HANOVER CENTRAL HIGH SCHOOL STADIUM IMPROVEMENTS Cedar Lake, IN 46303

ADDENDUM TWO

Addendum Two (AD.02) to the drawings and specifications prepared by Gibraltar Design for Hanover Central High School Stadium Improvements – Press Box and Visitor Bleachers for Hanover Central School Corporation, Cedar Lake, Indiana.

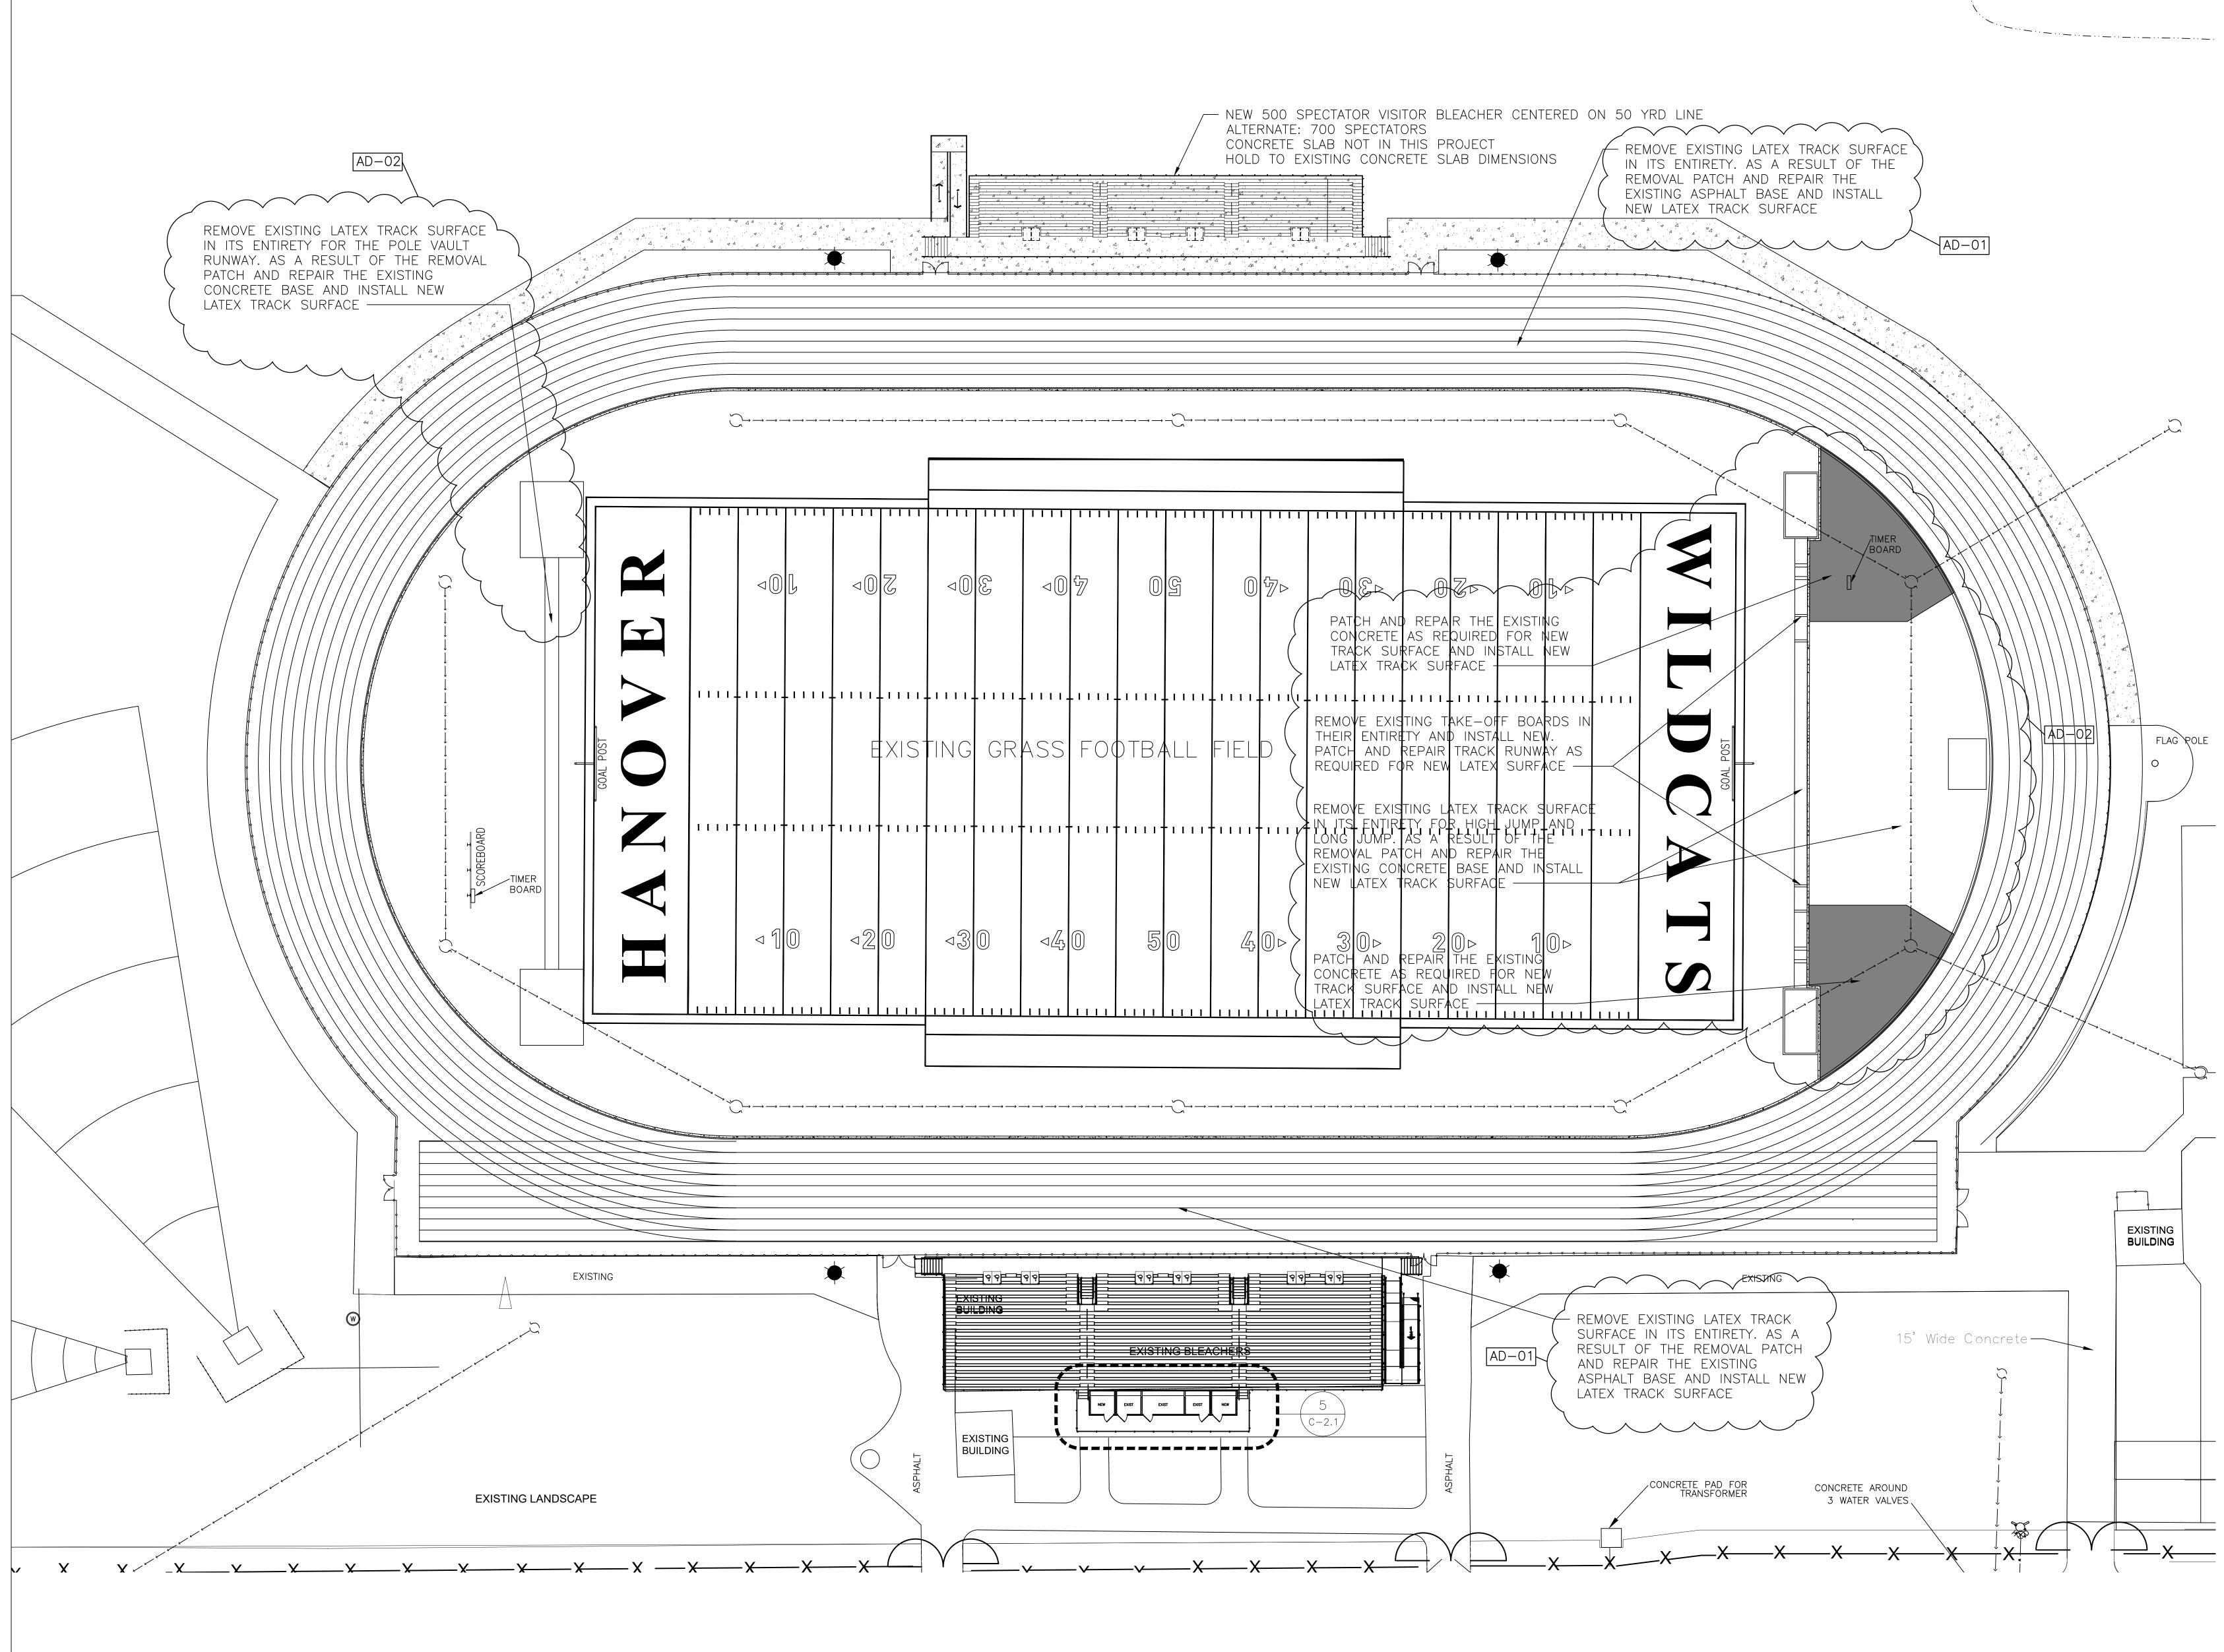
- A. Long Jump Take-Off Board Assembly: Complete assembly including foundation tray, blanking lid, take-off board and foul strip.
 - 1. Basis-of-Design Product: UCS; 519-2300.
 - 2. Provide non-beveled foul board edges for compliance with NFHS Rules.
 - 3. Size: 12 inches.

1. Sheet C-2.0

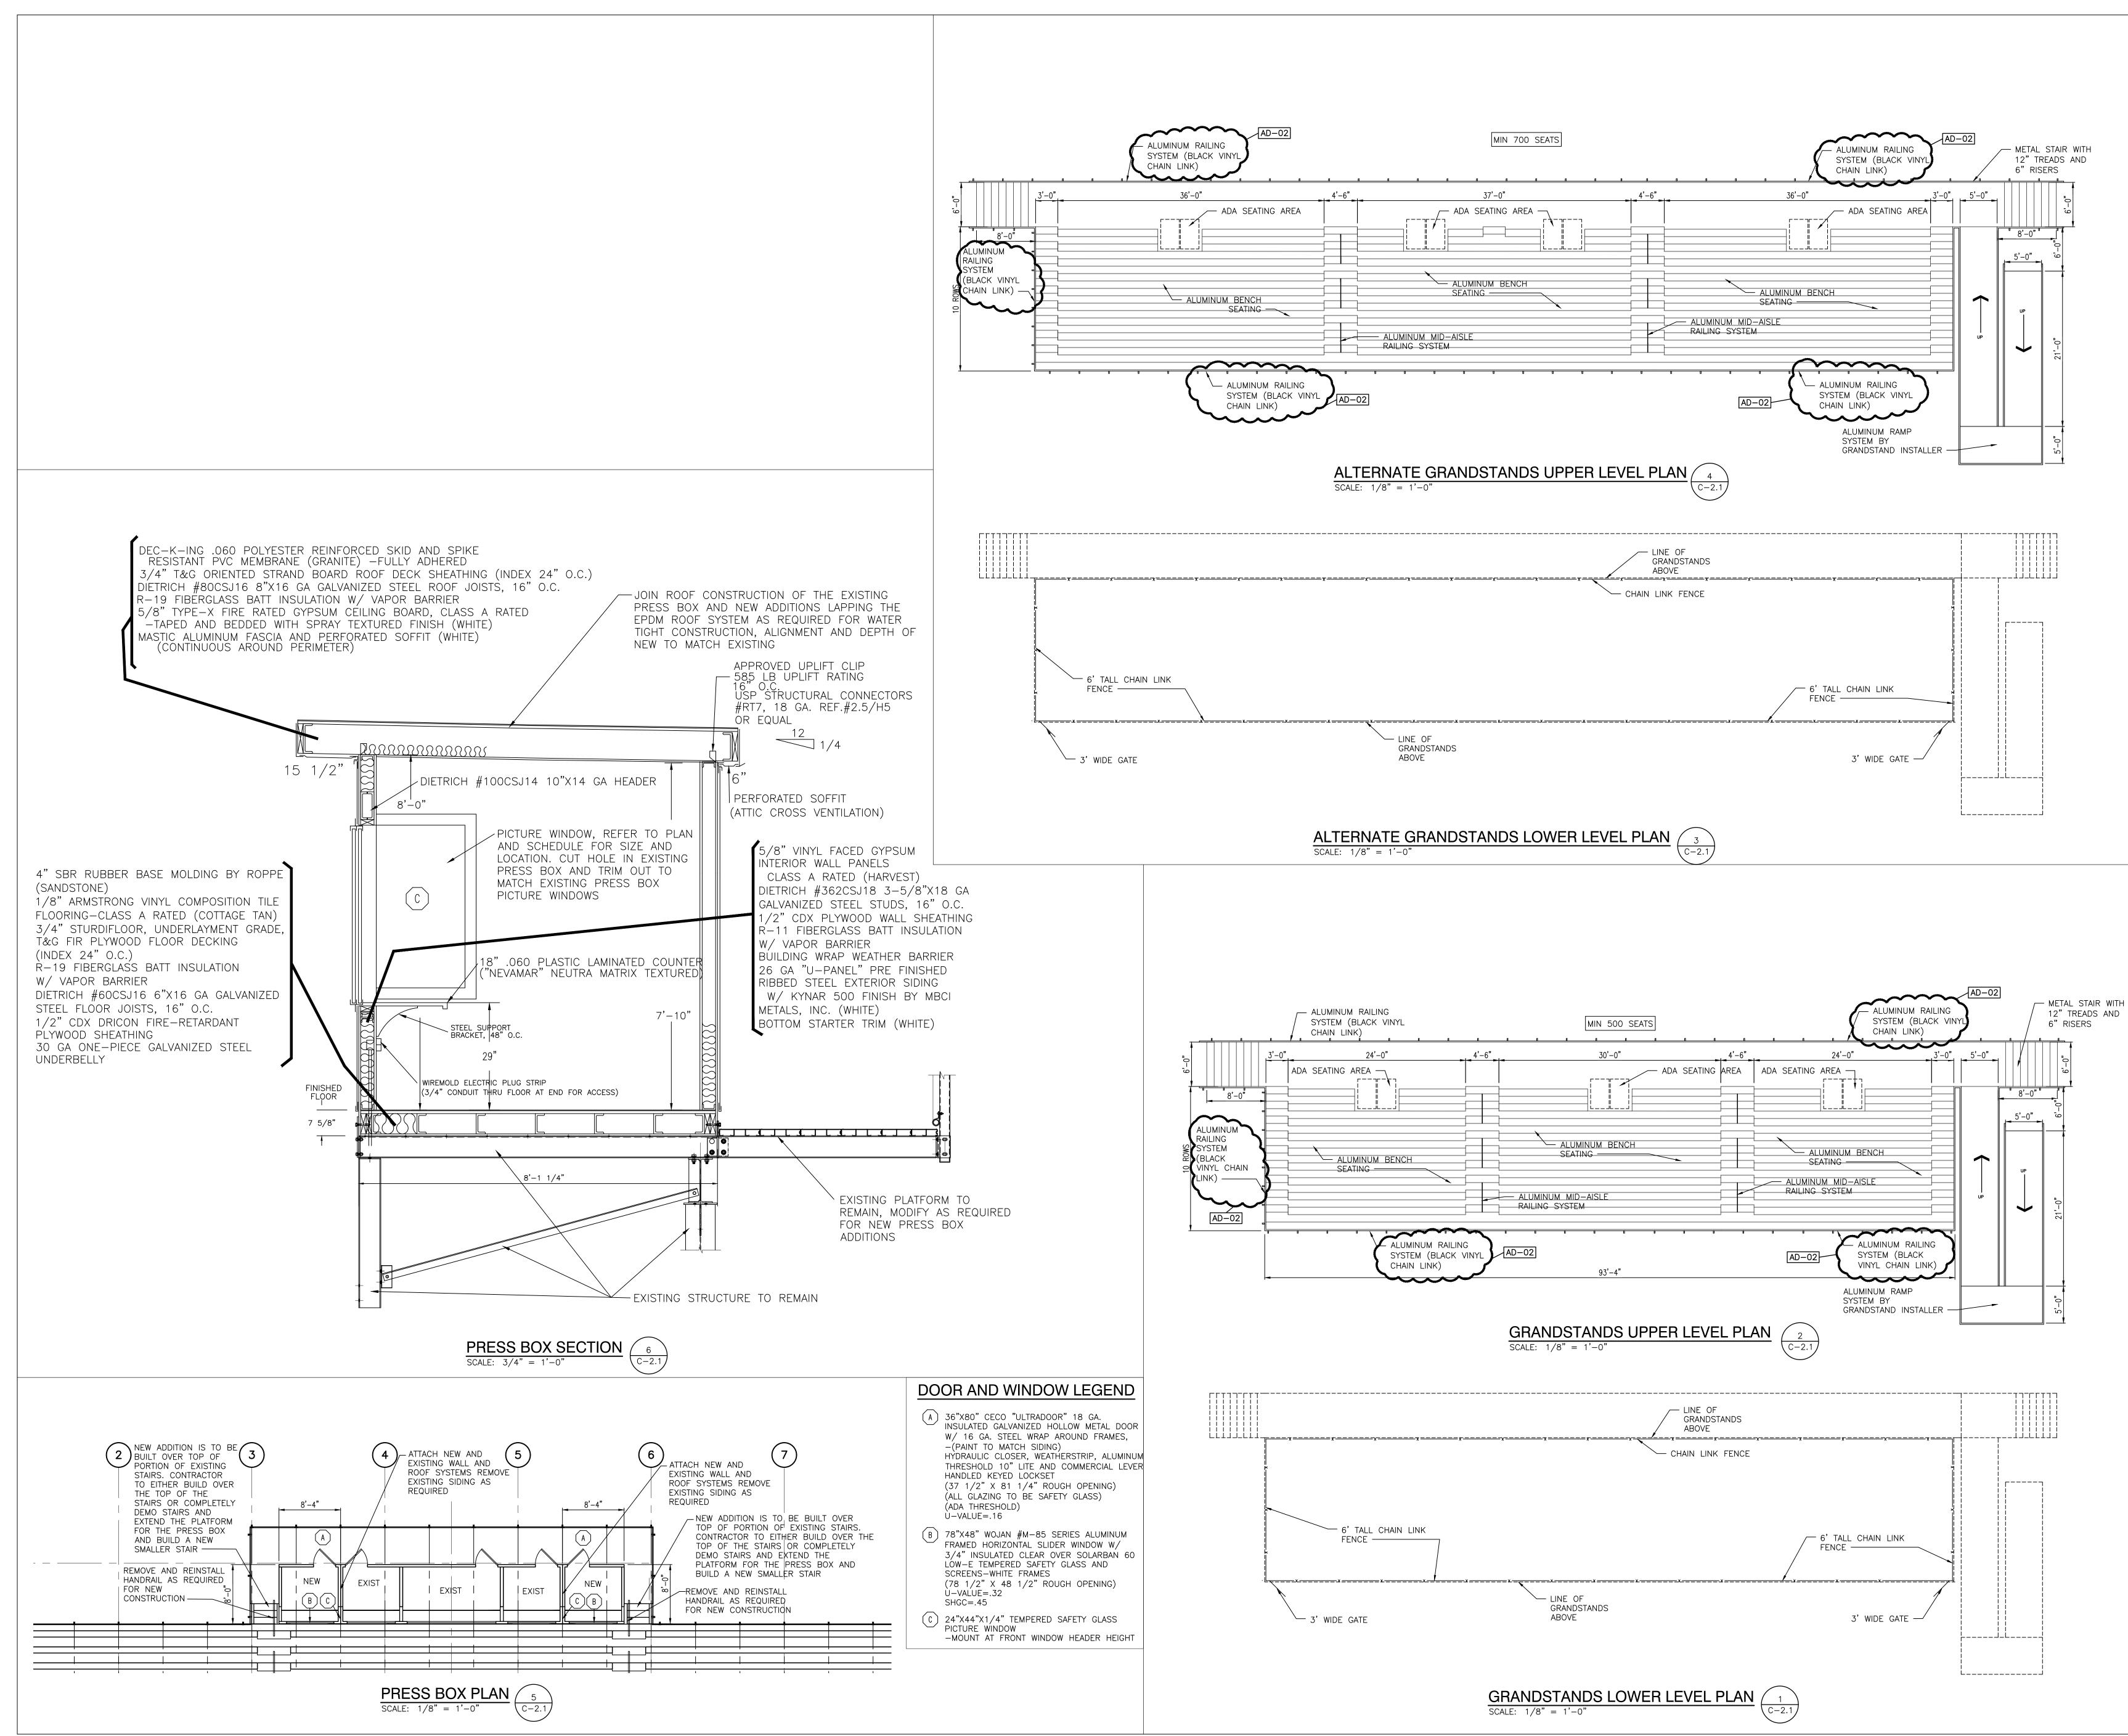
- A. Revise notes for Pole Vault, long Jump, and High Jump to indicate existing base is concrete in lieu of asphalt.
- B. Remove and install new take off boards for Long Jump

- C. Add notes to apply new latex surface on concrete at the North and south ends of East D-Zone.
- D. Add Long Jump Takeoff Board Detail.
